Info Only: Comments from Service
Engineering Engineering are in blue text.

Final Drainage Report

Overlook at Homestead Filing No. 1 El Paso County, Colorado

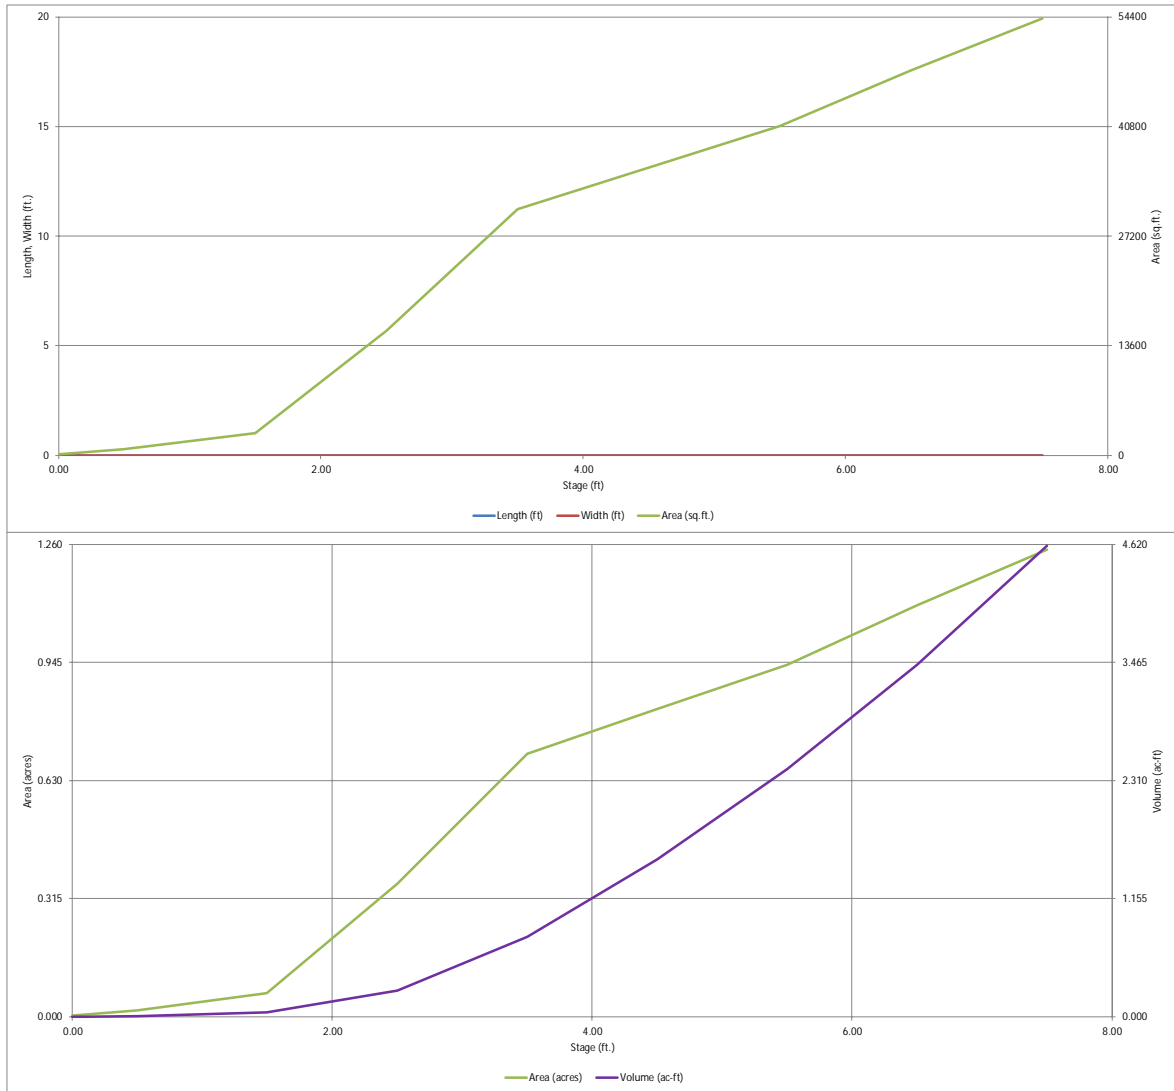
Why is this overridden?
It is 0.346 in the SDI form.

WQCV IS OVERRIDDEN ON
UD-DETENTION SHEETS AS
POND IS SIZED FOR THE
NON-EXEPMT WQCV.
DETAILED EXPLATATION
OF WQCV AND
EXEMPTIONS CAN BE
FOUND IN REPORT TEXT.

DETENTION BASIN STAGE-STORAGE TABLE BUILDER

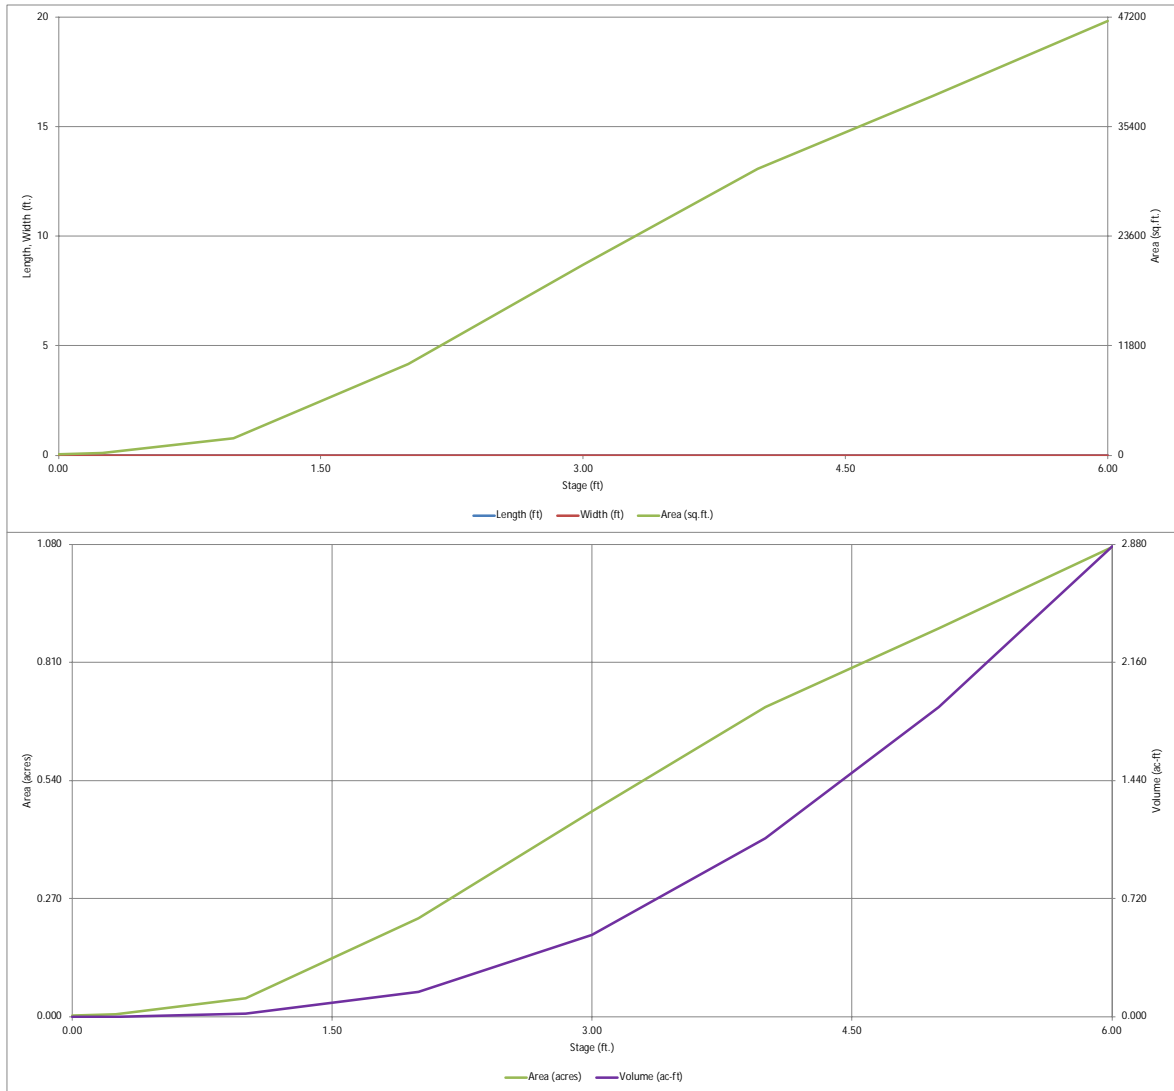
For best results, include the stages of all grade slope changes (e.g. ISV and Floor) from the S-A-V table on Sheet 'Basin'.

STAGE
ELEVATIONS
ADDED TO
SHEET

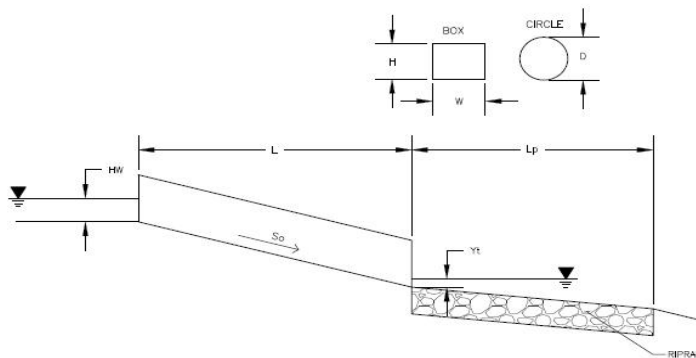
Please include the normal velocity for both minor and major storms. Printed profiles with HGL5 and HGL100 are required.

POND OUTFALL PIPE STORMCAD PROFILES AND FLEX TABLES INCLUDINING VELOCITY FOR MAJOR AND MINOR STORMS HAVE BEEN INCLUDED IN APPENDIX.

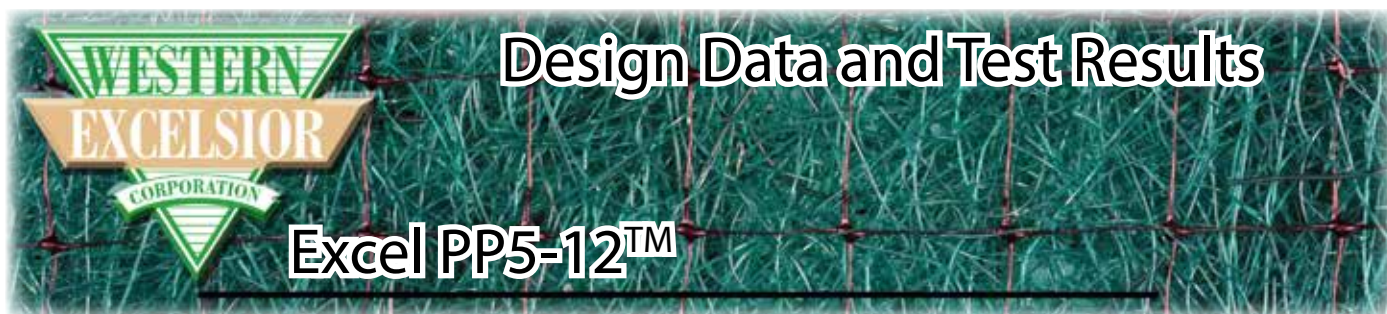
the channel depth
indicated in the
roadway
cross-section E is
1.75' and F is 8".
revise accordingly.

exceeds permissible
velocities in ECM.
revise and/or provide
necessary protection

DATA UPDATED. ANY CHANNEL WITH VELOCITY
GREATER THAN 5 FT/S IS CALLED OUT WITH TRM
PROTECTION
